Memorandum

To: NSPI
CC: STEVE PRONKO, VINCENT MUSCO
FROM: BOB FAGAN, RACHEL WILSON, DEVI GLICK, SHELLEY KWOK
DATE: MARCH 3, 2020
RE: COMMENTS ON NSPI 2020 IRP ANALYSIS PLAN AND ASSUMPTIONS

This memo provides draft comments on the Analysis Plan and the Assumptions for the 2020 NSP IRP. These comments include referencing the extent to which NSPI has or has not yet addressed the recommendations from Synapse’s Generation Utilization and Optimization Study, and from the Bates/White Fuel Audit concerns, as per the NS UARB’s letter of October 2018 addressing the IRP process.¹

Scenarios Table For Discussion

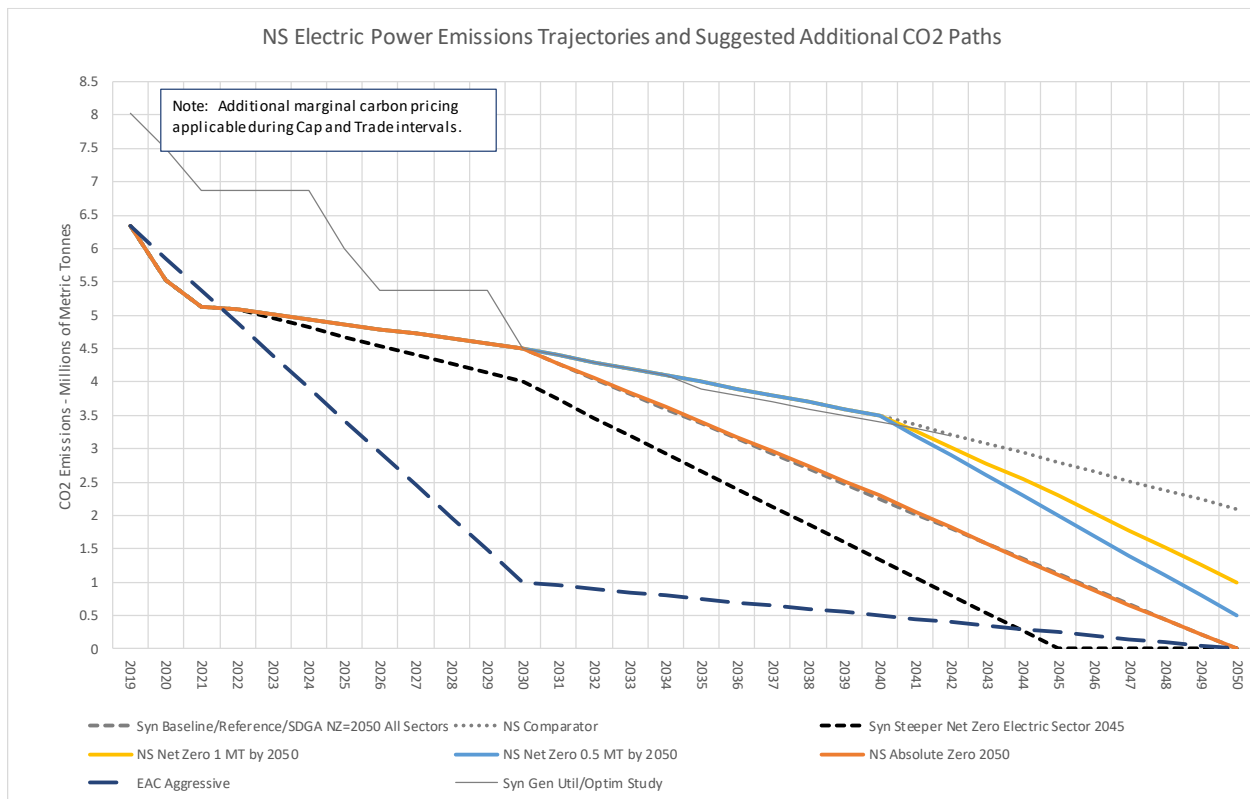
The following tables illustrate our recommendation for consideration of additional scenarios, beyond (or as a substitution for some of) those contained in NSPI's "Scenarios" plan.

The eleven scenarios listed contain a mix of different levels of emission constraints, load components, DG representation, and inertia ("regional integration") consideration. We are prepared to discuss these additional considered scenarios. The formulation of these additional considered scenarios was based on the following:

- Stricter interpretation of "net zero" emissions policies. Three regimes are defined/labeled: 1) Cap and Trade I; 2) Cap and Trade II (steeper path); 3) steepest path of CO₂ reduction, in line with electric sector carbon budget contained in the Ecology Action Center report.⁴

- Producing an "envelope" of net load effects reflecting the critical components of 1) reduced load through DSM, and 2) increased load through electrification. The load scenarios represented here reflect a mix of base, mid, and max DSM levels;⁵ and a presumption of two different "electrification" states: low (or baseline), and high.⁶

- Two different states for hard-coded, DG resources in the model; we anticipate that these resources would primarily be a mix of solar PV and small-scale batteries, but we also use this scenario to include a "max" DSM path.

- Room for "one off" scenario definition that could be further refined to reflect the intent to run a number of different scenarios with a set mix of net load, emissions, DG, and inertia parameters. This is also how additional scenarios such as a "Mersey" scenario could be handled (as the converse to whatever baseline Mersey status is used in the main set of runs).

- In all cases except the "EAC" scenario, we have excluded any "hard coding" of coal retirement paths, as our expectation is that emissions constraints and the marginal emissions cost construct should economically define the retirement path.

- In all instances, we assume demand response resources are handled separately as a supply side option. Alternatively, or supplementary, it would be possible to more carefully define a "DG" parameter that includes such DR resources.
